STANDARD DRAWINGS

**ADDENDUM No. 7**  
**Published March 5, 2021**

City of Fresno Department of Public Works  
2600 Fresno Street  
[www.fresno.gov](http://www.fresno.gov)

CITY OF FRESNO  
 S-5B

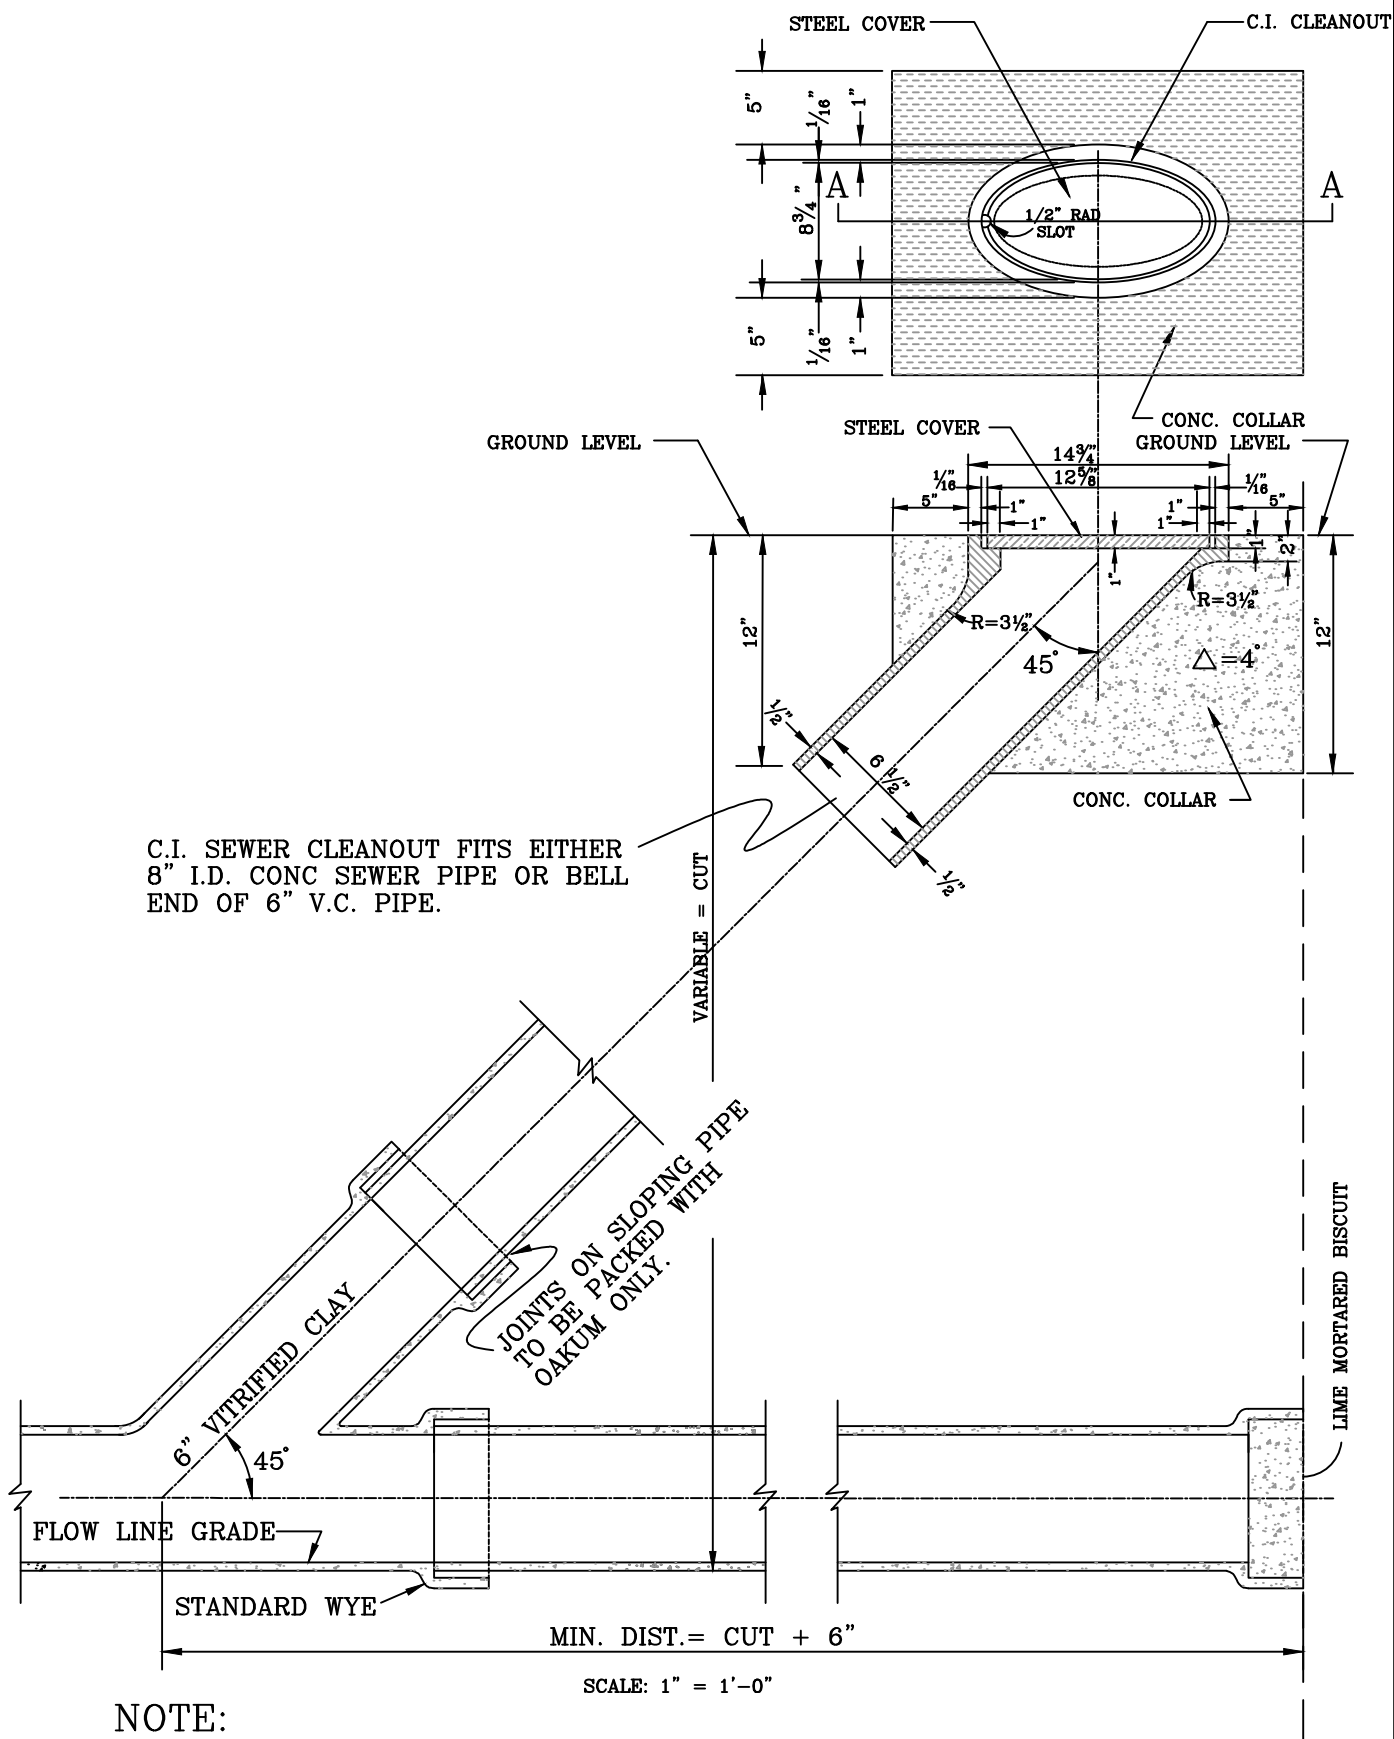
- S-5B** Added Note 8 regarding placement of manhole cover opening.
- S-7** Replace "S-7" with "S-7A and S-7B"
- S-8** Changed house branch Tee Fitting material to SDR35 to match uniform plumbing code  
Changed compression fitting to Gasket PVC Hub  
Added "Total gap not to exceed 1/2'" note to ensure proper connection is made.
- S-9** Clarified Note 4 regarding maximum extension of the saddle into the sewer main.
- S-10** Replace "Ref. Std. Dwg. P-40" with "Ref. Std. Dwg. P-48"
- S-11A** Added note to "Min. Model Height" to address heights less than minimum.
- S-12** Correction to Note 2.

CITY OF FRESNO  
**E-1**

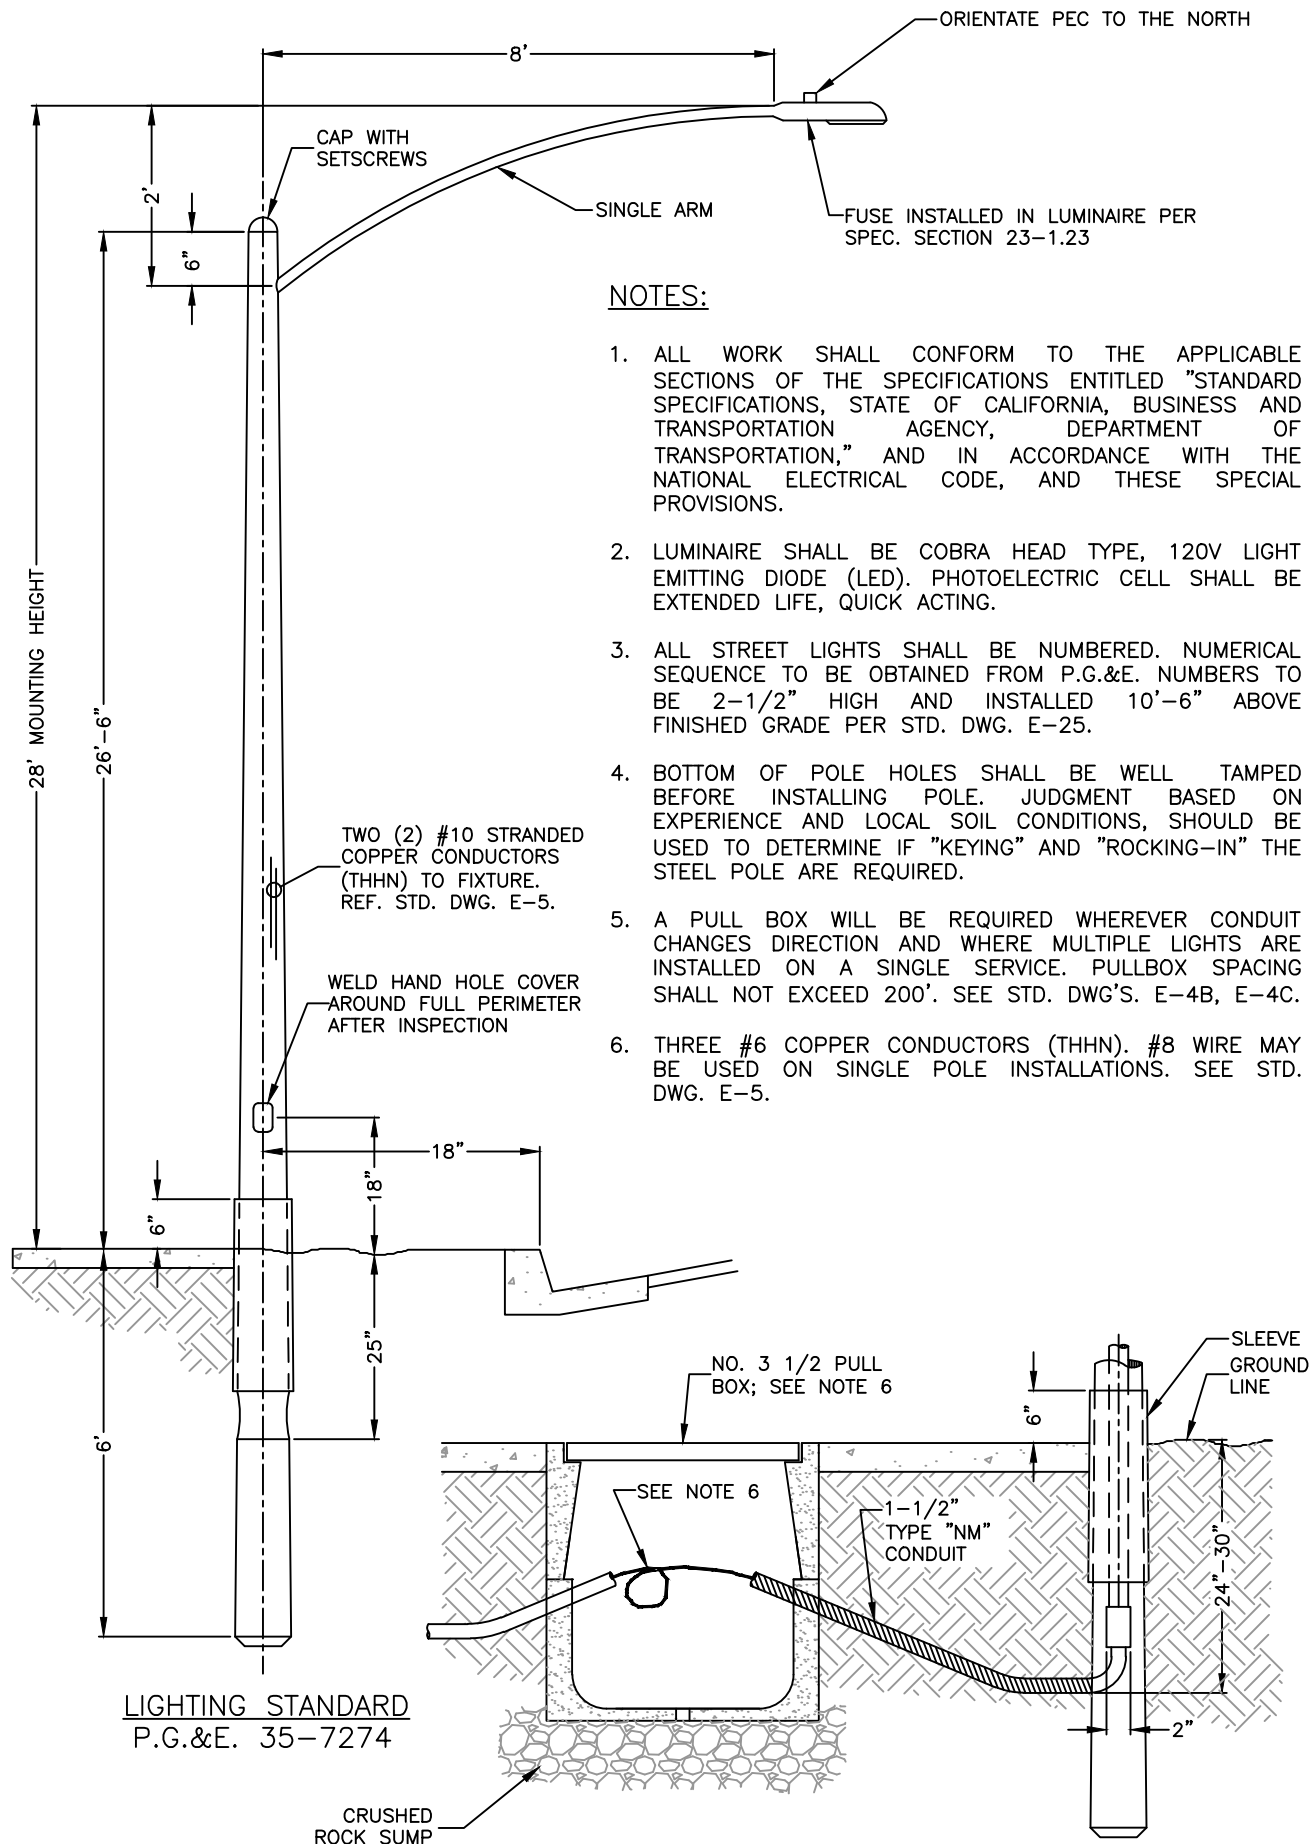
<b>E-1</b>	<ol style="list-style-type: none"> <li>1. <b>Note #1 revised</b> to include year of issuance for Caltrans Specifications applicable to detail (1997).</li> <li>2. <b>Updated pull box</b> to include crushed rock sump base material. Pull box revised to match STD. DWG. E-4A.</li> <li>3. <b>Callout:</b> "ORIENTATE PEC TO THE NORTH", <b>Revised to read:</b> "ORIENT PEC TO THE NORTH"</li> <li>4. <b>Callout:</b> "WELD HAND HOLE COVER AFTER INSPECTION" <b>Revised to read:</b> "WELD STEEL HAND-HOLE COVER AROUND FULL PERIMETER AFTER INSPECTION".</li> <li>5. <b>Callout:</b> "TYPE "NM" CONDUIT, REFER TO TABLE ON STD. DWG. E-27 FOR MORE INFORMATION" <b>Revised to read:</b> "TYPE "NM" CONDUIT, REFER TO TABLE ON STD. DWG. E-27 FOR DETAIL AND MORE INFORMATION".</li> <li>6. <b>Callout:</b> "CONDUIT PER 23-3.11 AND STD. DWG. E-6" <b>Revised to read:</b> "CONDUIT PER SPEC. SECTION 23-3.11".</li> <li>7. <b>Callout:</b> "FUSE INSTALLED IN LUMINAIRE PER SPEC. SECTION 3.12" <b>Revised to read:</b> "FUSE INSTALLED IN LUMINAIRE PER SPEC. SECTION 1.23".</li> <li>8. <b>Callout:</b> "TWO (2) #10 STRANDED COPPER CONDUCTORS (THHN) TO FIXTURE." <b>Revised to read:</b> "TWO (2) #10 STRANDED COPPER CONDUCTORS (THHN) TO FIXTURE. REF. STD. DET. E-5".</li> <li>9. <b>Dimension</b> for luminaire arm length: "12" <b>Revised to read:</b> "SEE LMA CHART"</li> <li>10. <b>Added LMA chart</b> for required luminaire arm lengths.</li> <li>11. Numbered existing notes, no changes made to existing requirements.</li> </ol>

CITY OF FRESNO  
**RW-7**

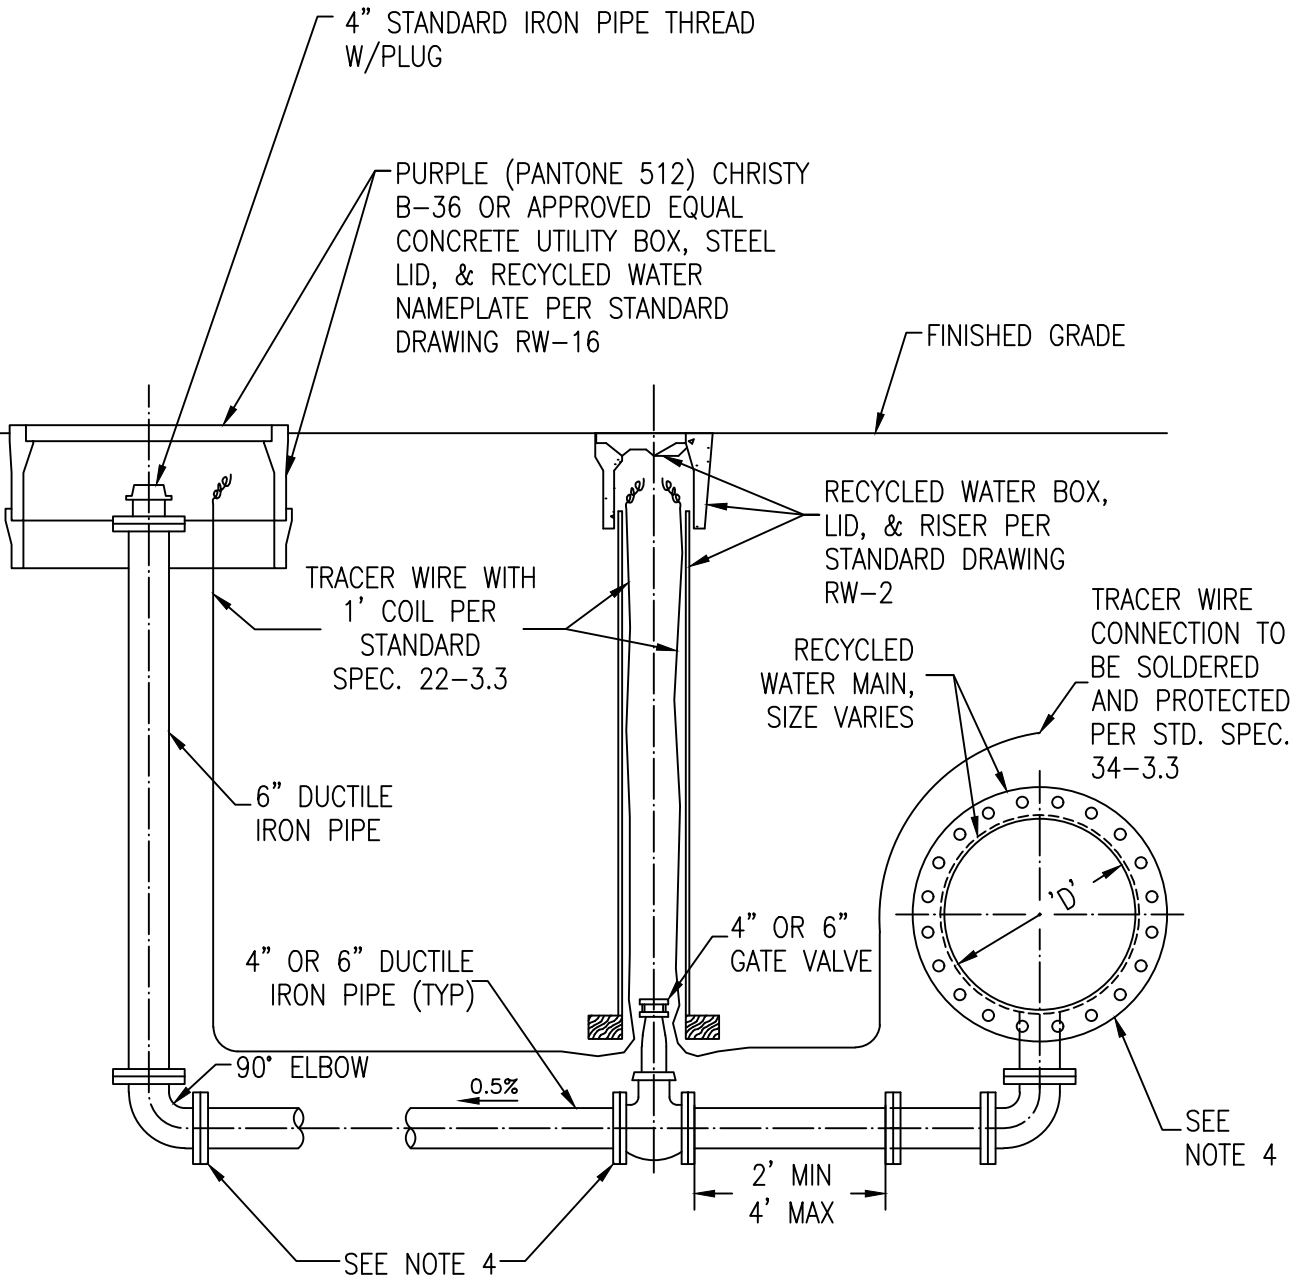
<b>RW-7</b>	<ol style="list-style-type: none"> <li>1. <b>Callout</b>: "PURPLE (PANTONE 512) CHRISTY METER BOX WITH LID (17" X 30") AND MARKED WITH THE WORDS "RECYCLED WATER"" <b>Revised to read</b>: "PURPLE (PANTONE 512) CHRISTY B-36 OR APPROVED EQUAL CONCRETE BOX, STEEL LID AND RECYCLED WATER NAME PLATE PER STANDARD DRAWING RW-16"</li> <li>2. <b>Callout</b>: "2" x REQUIRED LENGTH GALVANIZED STEEL PIPE TYPE "K" RIGID OR SOFT, CONTINUOUSLY WRAPPED WITH APPROVED PURPLE RECYCLED WATER MARKING TAPE" <b>Revised to read</b>: "2" x REQUIRED LENGTH GALVANIZED STEEL PIPE, CONTINUOUSLY WRAPPED WITH APPROVED PURPLE RECYCLED WATER MARKING TAPE"</li> <li>3. <b>Callout</b>: "TRACER WIRE WITH 1' COIL PER STANDARD SPEC. 22-3.3" <b>Revised to read</b>: "TRACER WIRE WITH 1' COIL PER STANDARD SPEC. 34-3.3"</li> <li>4. <b>Note 3</b>: "RESTRAIN ALL JOINTS PER SITY STANDARD SPECIFICATIONS SECTION 21-15.5" <b>Revised to read</b>, "RESTRAIN ALL JOINTS PER SITY STANDARD SPECIFICATIONS SECTION 33-14.5"</li> </ol>
